## ADDITIONAL INFORMATION

UNIT 10, JOHN F KENNEDY AVENUE, JOHN F KENNEDY INDUSTRIAL ESTATE, DUBLIN 12, D12 NX74

PLANNING APPLICATION REFERENCE: SD22A/0139

Figure 1: Extract from Dwg; MGS39042\_EL\_Rev6\_3 - Proposed Elevations and Proposed Illumination of Totem Signage

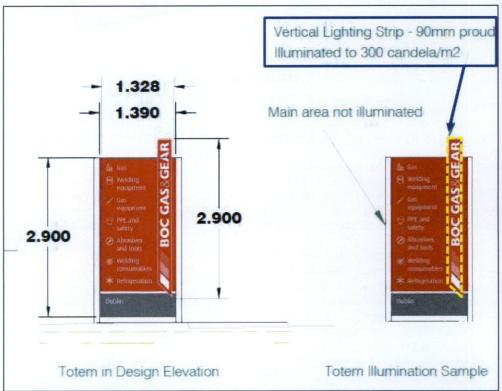
The applicant has not provided sufficient, consistent, drawings in relation to the proposed totem signage. To allow for a full assessment of this proposal the applicant is requested to submit the following:

Accurate plans and elevations of the proposed totem pole, including detail on the proposed materials and illumination. Drawings should include all key measurements, including height of the sign and depth of any projecting elements.

Response: Please see attached drawings with all key dimensions including the height of the sign the depth of projecting elements further details of the projecting elements of the sign are inclusive of drawing pack.

The proposed elevations below show that the vertical strip on the totem (highlighted with a yellow dashed line) will be internally illuminated, and the rest of the sign will not have any illumination. The proposed elevations also show the dimensions of the proposed totem signage.

Figure 2: Extract from Dwg; MGS39042\_EL\_Rev6\_4 – Foundation location and proximity to Proposed Totem Signage

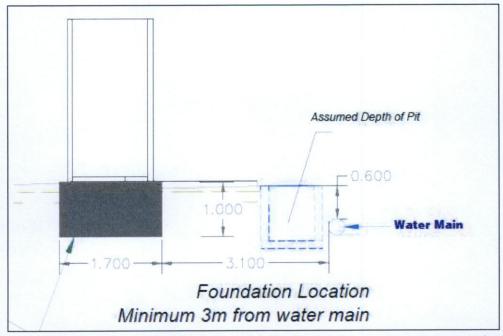
## 2. A structural drawing which details the totems structural make-up.

Response: Please see below the Totem detailed drawing which provides detail on the Totem's foundations and the structural make-up of the signage and the proximity of the signage to the nearest utilities. A Utilities Survey is included in the further information response. This survey was commissioned as a response to South Dublin County Council's request for further information.

Figure 3: Extract from Dwg; MGS39042\_EL\_Rev3\_5 - Plan view of the Totem signage and proximity to Watermain

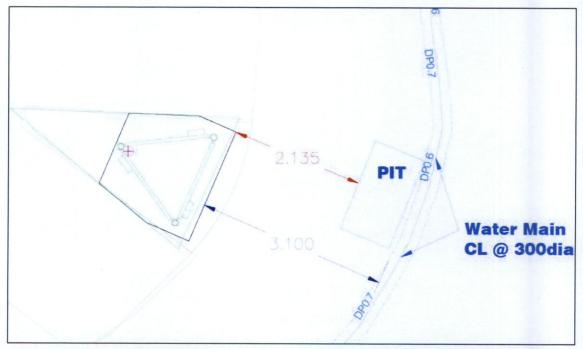
3. A drawing in plan and cross-sectional view showing the distance between the foundation of proposed totem sign and existing 300mm surface water sewer east of site. The minimum setback distance to existing surface water sewer shall be 3m as per Greater Dublin Regional Code of Practice for Drainage Works.

**4.** A drawing showing the distance between the foundation of proposed totem sign and any adjacent watermains and/or wastewater.

Response: Please see the drawing below which shows a cross-sectional view showing the distance from the totem signage and foundation to the surface water sewer. It is noted that the sewer is over 3m metres away from the proposed development which abides by the Guidelines of the Greater Dublin Regional Code of Practice for Drainage Works. As part this response to South Dublin County Council's request for further information a Utilities Survey was commissioned and is included as an enclosure of this FI response.

Response: The drawing listed is in response to item 4 of the further information and shows a plan view of the proximity of the totem signage foundations to the watermains. The response proves from the Utilities Survey that the distance between the foundation and watermains is sufficient to allow for the development of the totem.
